## Access Compliance Report Public Rights-of-Way (Curb Ramps)

Intersection ID: 31200 Main Street: OAKTON\_GLEN\_CT Cross Street: OAKTON\_HUNT\_DR Location: NE
ADA ID: 30F6CCCEB8C2 Ramp Type: PerpDiag Initial Pass/Fail: Fail Overall Compliance: No Severity Score: 13.75

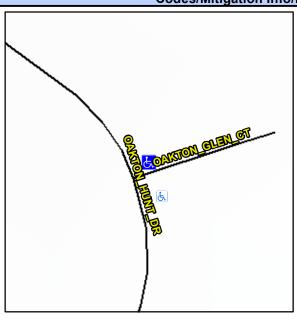
Not Found, R304.2.2, R304.5.3

Field Measurements/Component Compliance					
Compliance Description		Data	Comp	liance Description	Data
N/A	Ramp Length (in)	48.0	No	Ramp Slope (%)	10.7
Yes	Ramp Width (in)	48.0	No	Ramp XSlope (%)	4.2
N/A	Flare Type LT	N/A	N/A	Flare Type RT	N/A
N/A	Flare Slope LT (%)	N/A	N/A	Flare Slope RT (%)	N/A
N/A	Flare Traversable LT?	N/A	N/A	Flare Traversable RT?	N/A
N/A	Landing Length (in)	N/A	N/A	DWS Provided?	N/A
N/A	Landing Width (in)	N/A	N/A	DWS Contrast?	N/A
N/A	Landing Slope (%)	N/A	N/A	DWS Length (in)	N/A
N/A	Landing X Slope (%)	N/A	N/A	DWS Full Width?	N/A
N/A	Landing Curb? (Y/N)	N/A	N/A	DWS Offset (in)	N/A
N/A	Shared Landing?	N/A			
N/A	Gutter Ponding?	N/A	N/A	Gutter Slope (%)	N/A
N/A	Gutter Lip Ht (in)	N/A	N/A	Gutter X Slope (%)	N/A
N/A	Painted X Walk1?	No	N/A	Painted X Walk2?	No
	X Walk 1 Direction	To W		X Walk 2 Direction	To S
N/A	X Walk 1 Width (in)	N/A	N/A	X Walk 2 Width (in)	N/A
	X Walk 1 Slope (%)	1.7		X Walk 2 Slope (%)	0.9

Remove & Replace Curb Ramp With Two New Directional Ramps or Equivalent.
